UNITED STATES PATENT AND TRADEMARK OFFICE

APPLICATION NO.	FILING DATE	FIRST NAMED INVENTOR	ATTORNEY DOCKET NO.	CONFIRMATION NO.
09/836,014	04/17/2001	Robert Veilleux	186.013US1	7009

Office Action Summary

DETAILED ACTION

FIG. 10

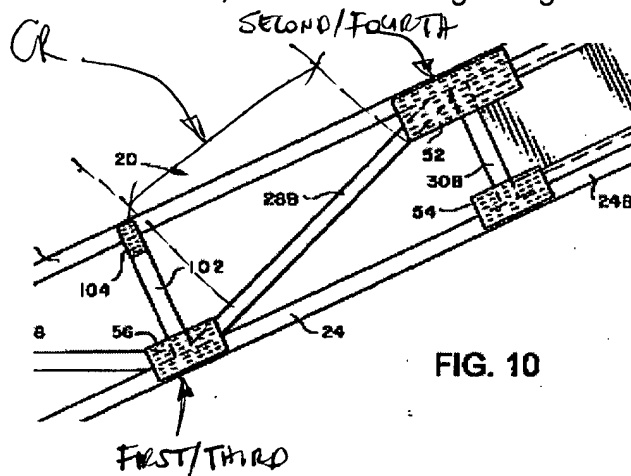
web structure displays a laminated panel (30A, 34A/B, 50) the panels are a series of vertical planks having upper and lower sides joined to upper and lower chords (22, 24). Regarding claim 3, each of the connector members at the opposite end of the web structure is adhesively joined to a chord member and to an innermost plank (30A, 30B) of the laminated panel (34A,34B,50). In reference to claim 4, the connector members of the web structure have upper and lower edges secured to the chords by finger joints (column 4, lines 23-26). Regarding claim 5, the planks (74) of the connector member of the laminated panels are glued edgewise to one another (column 7, lines 4-9). In reference to claim 6, the web structure further includes a central region (CR) free of connector members, see below. Regarding claim 7, the laminated panels

(30A,34A/B,50) define uninterrupted surfaces adhesively and edgewise joined together. In reference to claim 8, the connectors (28,28A/B) are adhesively secured in addition to being gusseted together. Further regarding claim 14, the first and third ends are secured to the lower/first chord (24) and the second and fourth ends are secured to the second/upper chord (22), see above.
